TO: JAMES L. APP, CITY MANAGER
FROM: RON WHISENAND, COMMUNITY DEVELOPMENT DIRECTOR
SUBJECT: CITY OF EL PASO DE ROBLES GATEWAY DESIGN STANDARDS
DATE: MAY 6th, 2008

Paso Robles Gateway Plan: Design Standards

Prepared for the City of Paso Robles by: **HDR** | Town Planning
In Association with:
Moule & Polyzoides
Architects and Urbanists

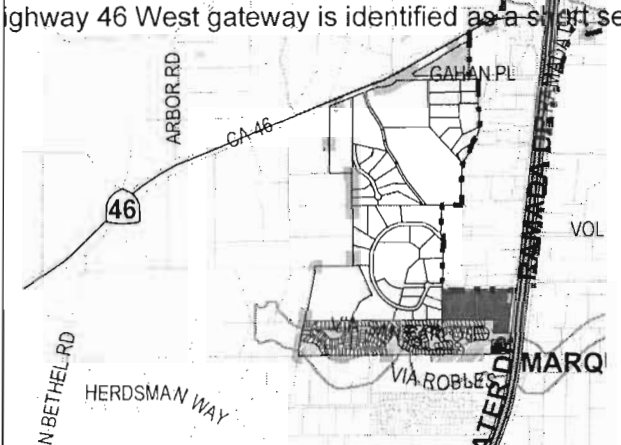
5 / 1	<p>The plan states that every gateway is currently in a T2 Rural environment. It might be noted early that the T2 zone includes suburban and rural residential development at up to one unit per acre. See comments above.</p>
14	<p>The Plan describes the Town and Country corridors but neglects to mention that these</p>

Page/Paragraph	Comments
	<p>are unincorporated areas. It lists city policies but does not inventory County policies or standards that would apply to them; it seems that all parties would benefit from a review in the Plan of existing County policies. This section could also list additional action items for City and County completion, such as the following:</p> <ul style="list-style-type: none"> • Work with the County to create design standards that correspond to the ones listed in the Plan. • It might be worth including an action to develop a cooperative approach between the City and the County for the Purple Belt. • A landscape assessment might be prepared with the County to “pin down” the starting point, viewshed, sensitivity and issues of each corridor.
16	<p>For this and other corridors, some clarification of the corridor length, or an identifier or scale would be helpful. Major intrusions could be identified that need to be addressed, as could all of the gateways be treated. The County would have the benefit of understanding some of the issue areas that may need attention. Or, a specific second study could be proposed for this and other corridors.</p>

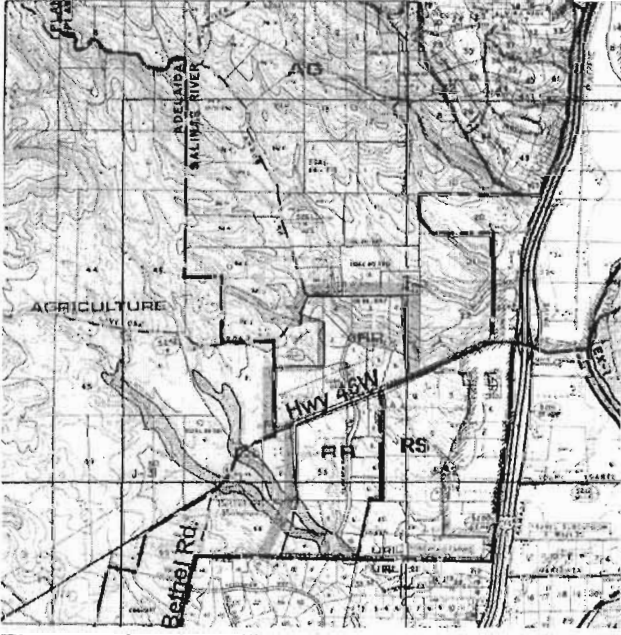
20	<p>South River Road is noted as having an attractive rustic character south of Charolais, and a comment is made that if the city extends southward, the road ought to have an avenue character as a transition. It might be helpful to establish interim County policies for this and other road segments that are outside the Sphere of Influence. They may be long-term protection of the desired character, since no policies exist for urban expansion here and in some other adjacent corridors.</p>
21	<p>The discussion and list in this section are an example of how to relate the Plan to the County. South Vine Street is partly within unincorporated urban area north of Highway 46 West. The Plan suggests working with the County to apply uniform standards that include key elements that are listed. The map of the future realignment is also very relevant to the following section on Highway 46 West.</p>
22	<p>Highway 46 West gateway is identified as a short segment from just west of the intersection with Gahan Place.</p>  <p>If this is the desired gateway, it seems to be shorter than the areas of Residential Rural (RR) and Residential Suburban (RS) category land, as shown in Figures 1 and 2.</p> <p>We have a concern that the gateway corridor may extend to Bethel Road intersection due to the allowed development and pressure for more winery tasting rooms and events. If a short gateway is desired, then would the suggested standards not be</p> <p>Figure 1: Urban Area in County Plan County Urban Reserve City Limits RS RR</p>

Page/Paragraph	Comments
	<p>considered in these larger RR and RS areas?</p> <div data-bbox="430 537 1084 1381" style="border: 1px solid black; padding: 10px; margin: 10px 0;">  <p>Figure 2: Rural and Urban Areas Legend: AG = Agriculture RR = Residential Rural RS = Residential Suburban</p> </div> <p>We see the gateway study as part of a longer corridor to at least Bethel Road for scenic and rural character protection.</p> <p>Perhaps the Gateways Plan could identify this and other segments more in relation to the land issues that could weaken or threaten the gateway concept. A landscape assessment of each gateway is a useful way to present a strategic plan with specific solutions.</p> <p>The design recommendations include suitable concepts, and they could consider deep setbacks, guidance to site buildings in least visible locations, and use of vernacular architecture rather than stock suburban plans.</p>
